Ref. CRM/UNFCCC/0993

**Response to the request for review for 0993 Hainan Province Diaoluohu
Hydropower Project**

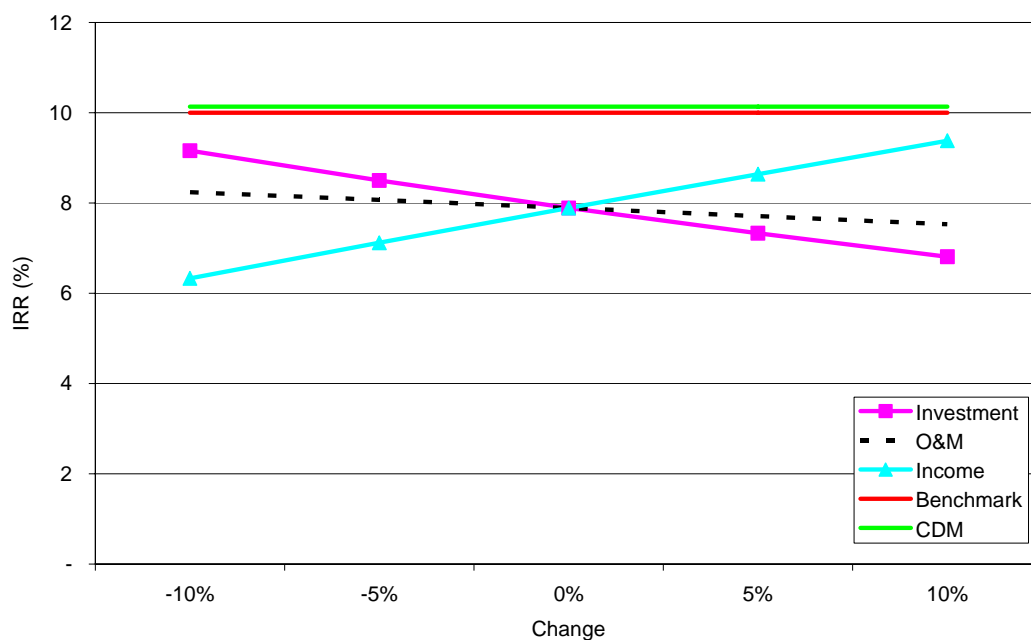
An IRR without CDM revenues of 7.9% is presented without sensitivity analysis. This IRR rises to 10.2% with CDM revenues. No sensitivity analyses were carried out.

Response to the second issue:

A sensitivity analysis was carried out as part of the project assessment. However, it is our understanding that the simplified modalities for small-scale projects do not require the use of the full "Tool for the demonstration and assessment of additionality", and therefore do not require a full sensitivity analysis to be presented. According to the Attachment A to Appendix B of the simplified modalities and procedures for small-scale CDM project activities, the additionality of a small-scale CDM project is demonstrated by one of three barriers. The project proponents have chosen to use the investment barrier as the main barrier for this project without presenting the sensitivity analysis in the PDD.

However, we are happy to provide the sensitivity analysis, by using total investment, operation and maintenance costs, and income of the proposed project without CDM to test if the project were economically attractive. The results of the project sensitivity analysis is summarised in the graph below. The graph shows very clearly that within +/-10% changes of the three elements for sensitive analysis, the IRR remains lower than 10% without CDM income. This sensitive analysis, thus, supports the conclusion that this project is additional.
